## Attachment 3

### Summary Comments of Public Comments

SUBJECT: P7713 National Capital Planning Commission, Washington, DC – Squares 378 and 379, 935 Pennsylvania Avenue, NW, Washington, DC – Draft Square Guidelines

L'ENFANT STREET STUDY  
EXTANT STREETS AND REMOVED SEGMENTS

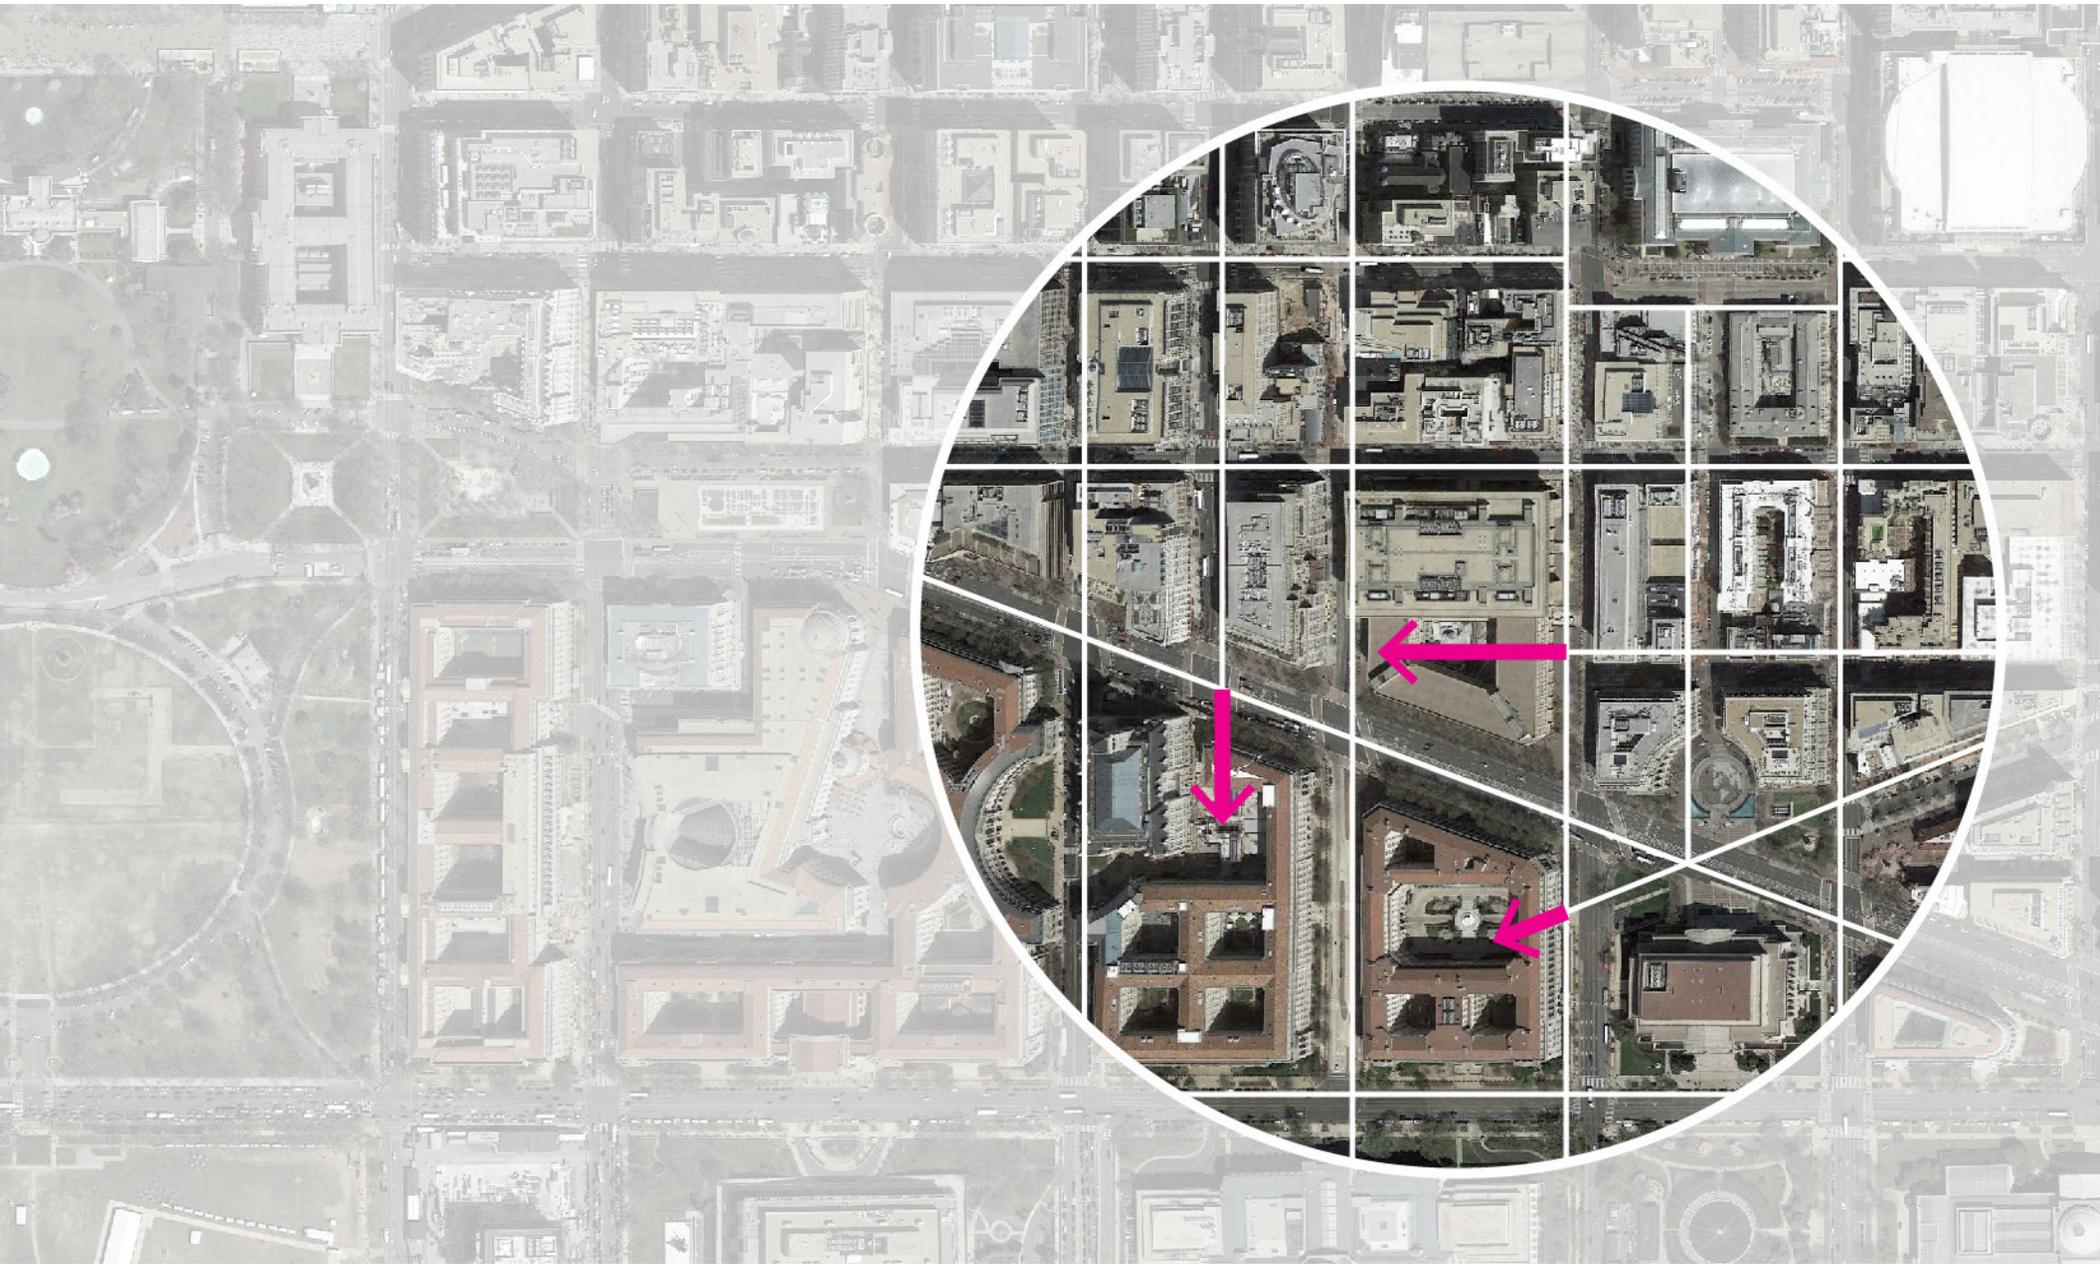
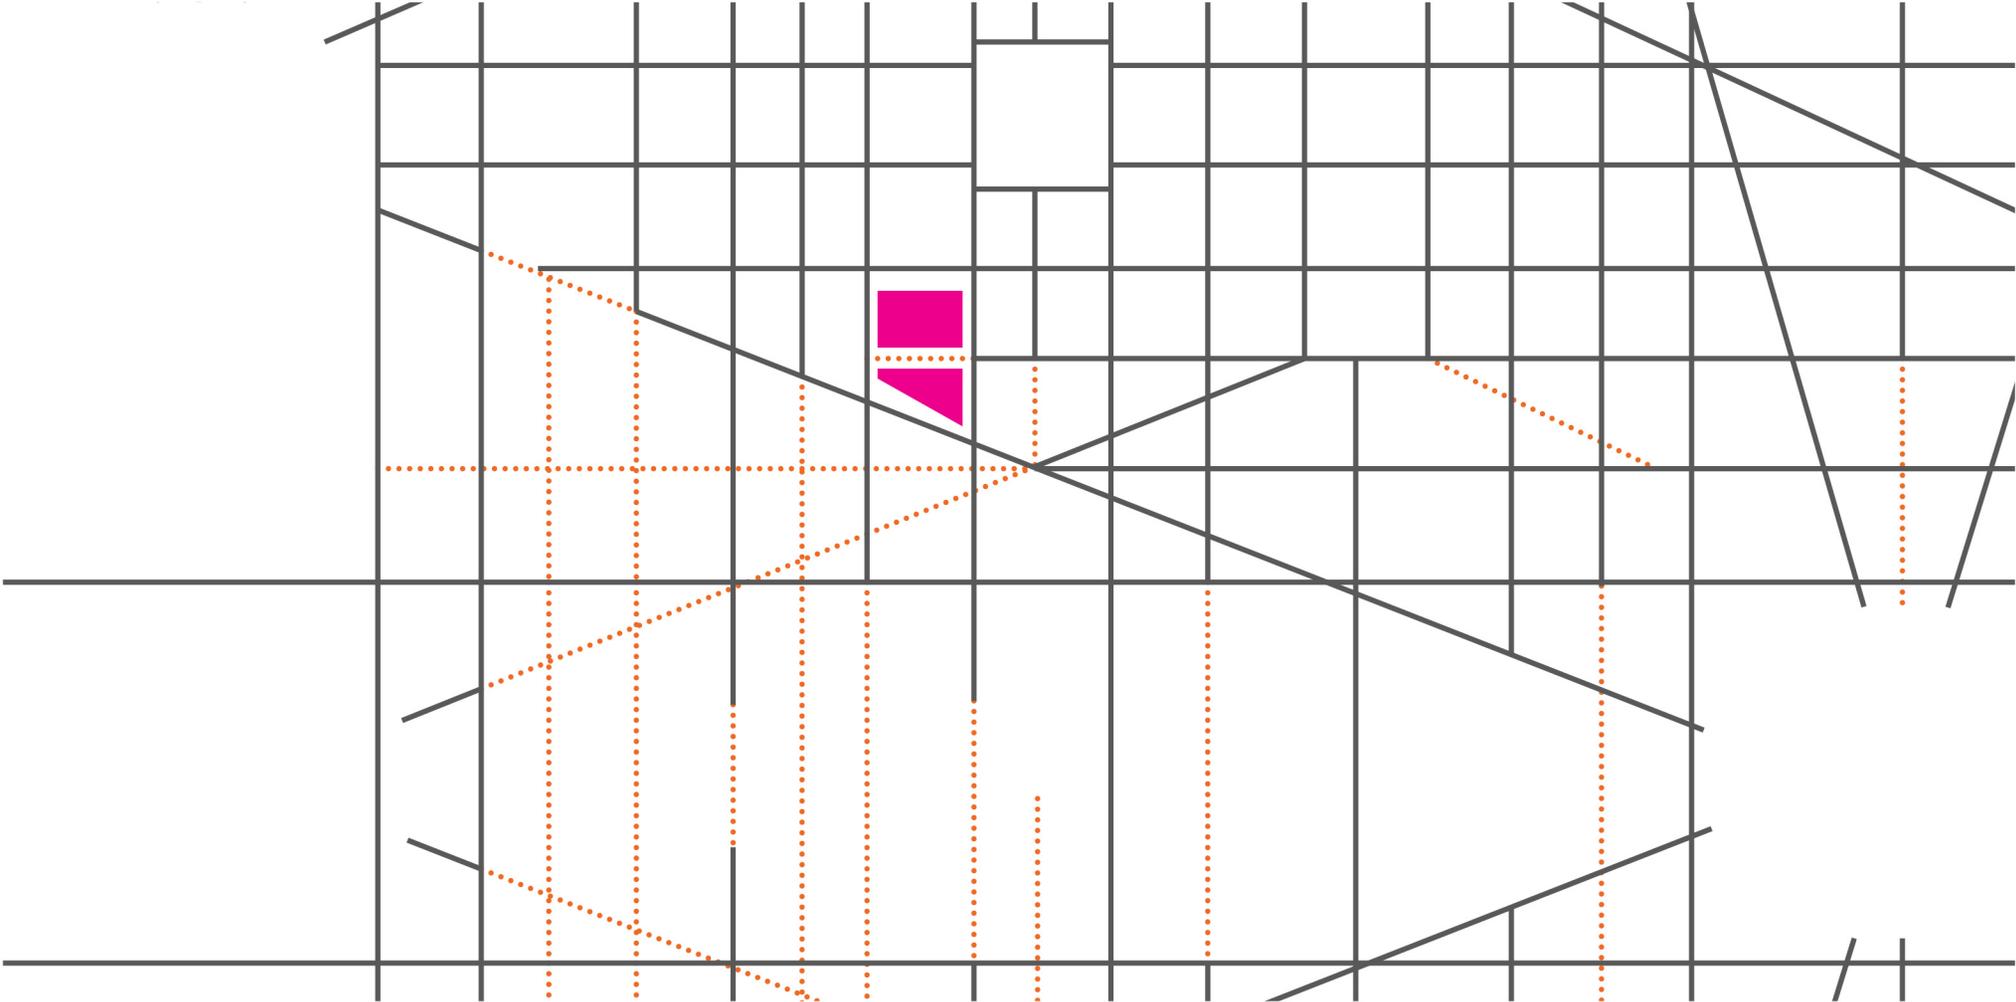
- Looking beyond the site, a full restoration of the former D Street would not restore the true L'Enfant vista to Pennsylvania Avenue since the existing building on the west side of 10<sup>th</sup> Street extends beyond the original L'Enfant Plan. Please refer to the attached diagrams outlining this condition.

- Therefore, D Street should only be restored as a pedestrian easement, and not necessarily a recorded public street. This pedestrian connection would provide the opportunity for the creation of an interior street frontage that can be designed and programmed to create a sense of destination and arrival.
